CASE # 2010-COA-262 (WD)	INDIANAPOLIS HISTORIC PRESERVATION COMMISSION STAFF REPORT	Hearing Date JULY 7, 2010
250 South Meridian Street WHOLESALE DISTRICT		<i>NEW CASE</i>
Applicant RAKESH GOYAL FOR 250 S MERIDIAN LLC mailing address: 16293 Deer Ridge Road San Diego, CA 92137		Center Township Council District: 19 Dane Mahern
Owner: Same as above		
CASE		
IHPC COA: 2010-COA-262 (WD)	<ul style="list-style-type: none"> • Modify the rooftop penthouse exterior, • Construct a stairwell enclosure addition on the southwest corner of roof, • Install handrails along the south and east parapet walls, • Install a rooftop deck covering, and • Install a street-level awning along Meridian Street 	
STAFF RECOMMENDATION: Approval with stipulations

CASE #2010-COA-262 (WD)

West side of building seen from street level

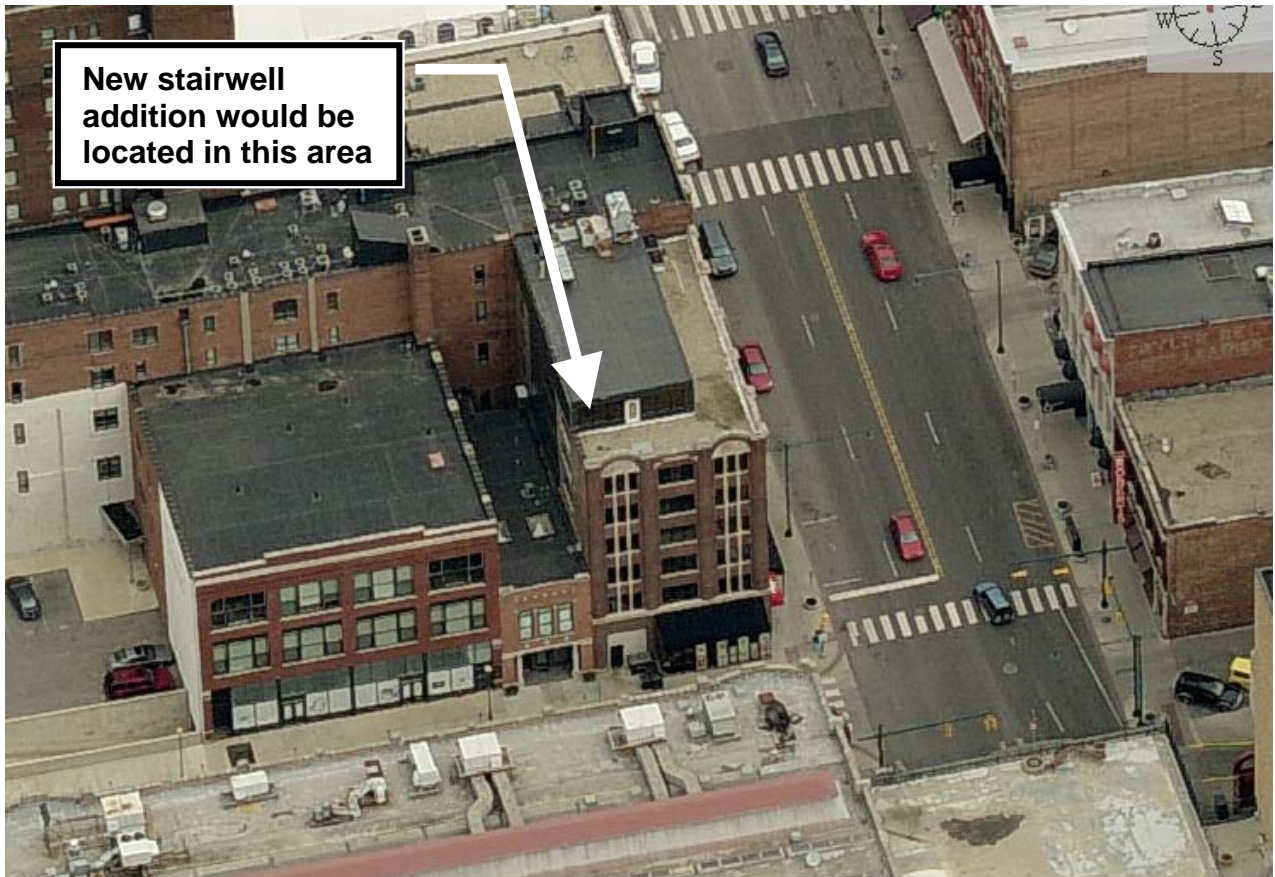
Stairwell addition: A new stairwell enclosure addition above the existing southwest firestair is being proposed to provide a second means of egress from the top floor penthouse unit. This was not part of the original request but has now become an issue since the interior layout of the penthouse space has changed. The existing terra cotta coping along the west wall will need to be removed for the new wall of the addition to be built on top of the existing party wall. This proposal puts the stair bulkhead very close to the Louisiana Street façade wall. At staff's request, the applicant has attempted to minimize the visibility of the addition from the street. The Wholesale District guidelines state that "*design additions to roofs (such as penthouses, storage space, elevator housings, decks and terraces, dormers and skylights) so they are inconspicuous from view from the public right-of-way and do not damage or obscure character-defining features.*"

**New stairwell
addition would be
located in this area**

South side of existing penthouse structure as built

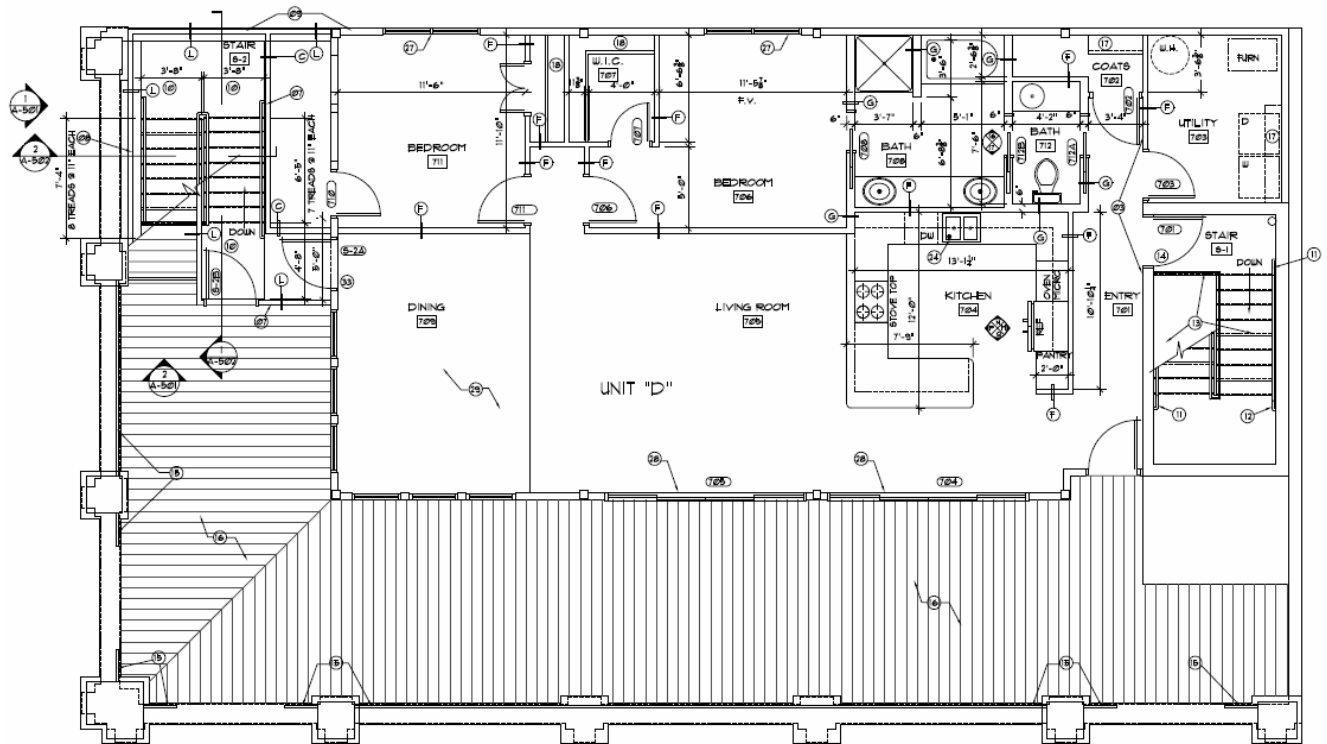
Penthouse window and door reconfiguration: Modifications were made to the original request for the penthouse windows and doors. The applicant is requesting for two bays of the east facing wall of the penthouse to receive four sets of metal sliding glass doors opening onto the new roof deck. Existing metal windows from the south side of the penthouse would be relocated to the east bay nearest the southeast corner of the penthouse. The west party wall would receive two sets of metal double hung 'lot line' windows.

Staff finds the request for sliding glass doors to not be inappropriate for the 1987 penthouse addition to this building. Additionally, these doors would not be visible from the street below. Regarding the new 'lot line' windows in the blank sidewall, the Wholesale District rehabilitation guidelines states that "*new openings may be considered in previous 'party walls'. Windows in 'party walls' are considered as temporary since future development may occur on the adjacent site. If new openings are placed in these areas, they should be compatible with the overall design on the building.*" Staff finds the requests for the window and door modifications to the east, west and south sides of the penthouse structure to be reasonable, and therefore recommends approval.

Proposed parapet railing details

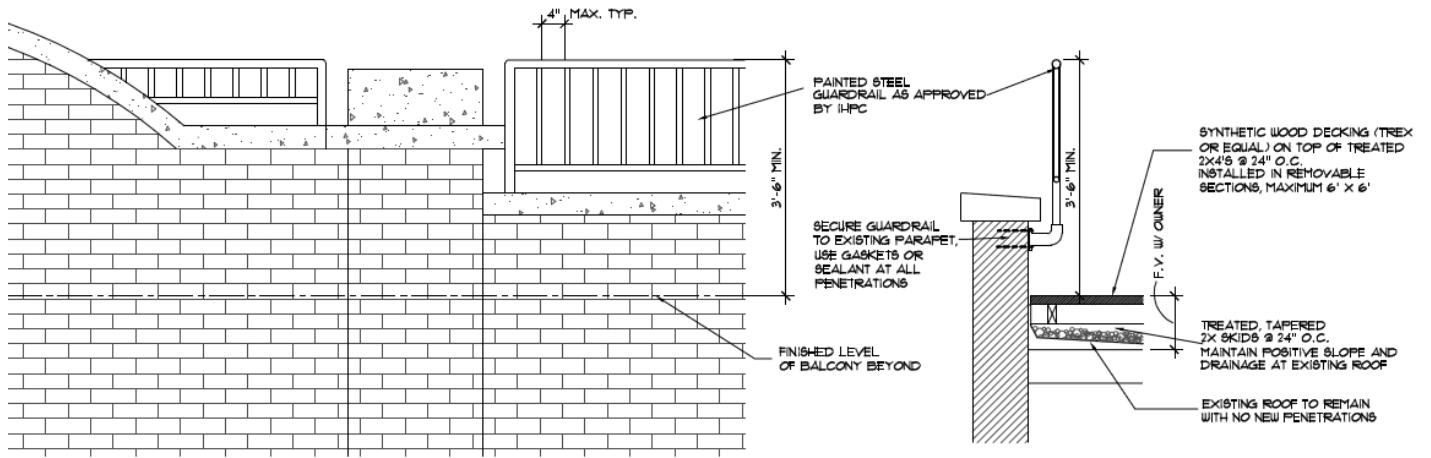
Railing modification: A new painted steel guardrail system would be attached to the inner side of the parapet wall. The railing detailing and installation method are similar to the previous request approved at the March 2004 Commission hearing. The applicant is proposing to increase the locations of the railings to provide a more continuous barrier that takes into effect the varying heights of the parapet wall. Because the railing is mounted to the inner side of the parapet walls, staff finds that the railing will be minimally visible from the street. Staff's recommendation remains the same to approve this element of the request.

- 3. New exterior metal panels shall match existing in finish, configuration, and method of construction.**
- 4. Railing supports and hardware must be installed using methods which cause as little damage as possible to the exterior walls. Fasteners at masonry locations should be installed in the mortar joints. Do not drill into or otherwise damage masonry (brick, block, structural tile, etc.).**

Entry doors to receive new awning

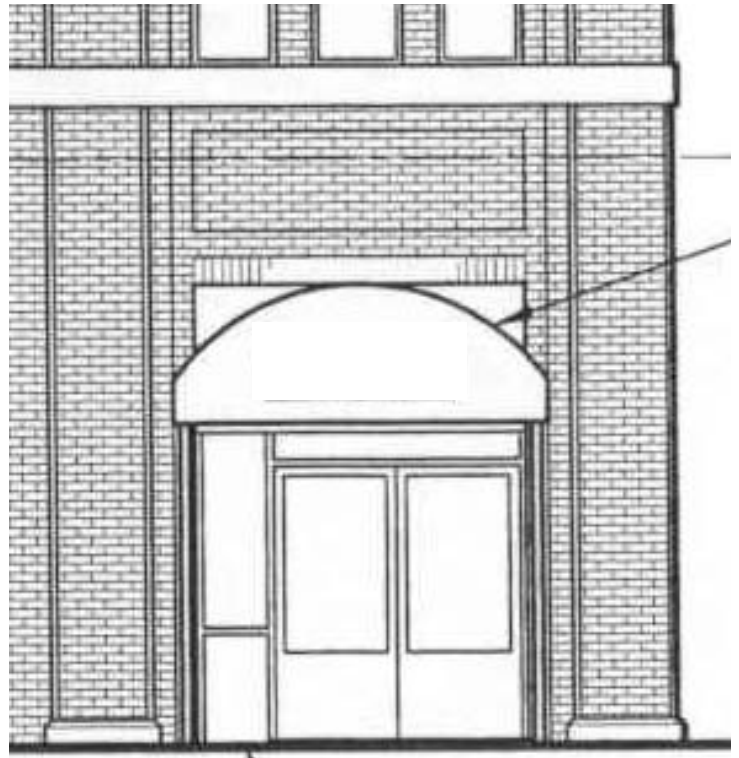
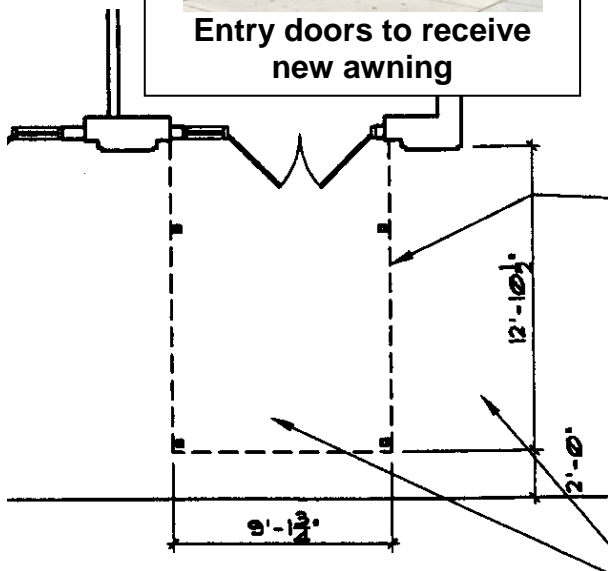
Ground floor entry awning: The applicant is asking to install a fabric covered vaulted canopy-type awning similar to the one that was approved as a part of the previous request above the northern-most entry doors along the Meridian Street side of the building. The applicant is not including any signage on the awning at this time. Staff's recommendation is unchanged regarding this part of the request.

- 5. Deck may not be higher than the lowest portion of the parapet wall.**
- 6. Awning shall be of fabric construction on a metal frame. High-sheen finishes are not permitted.**
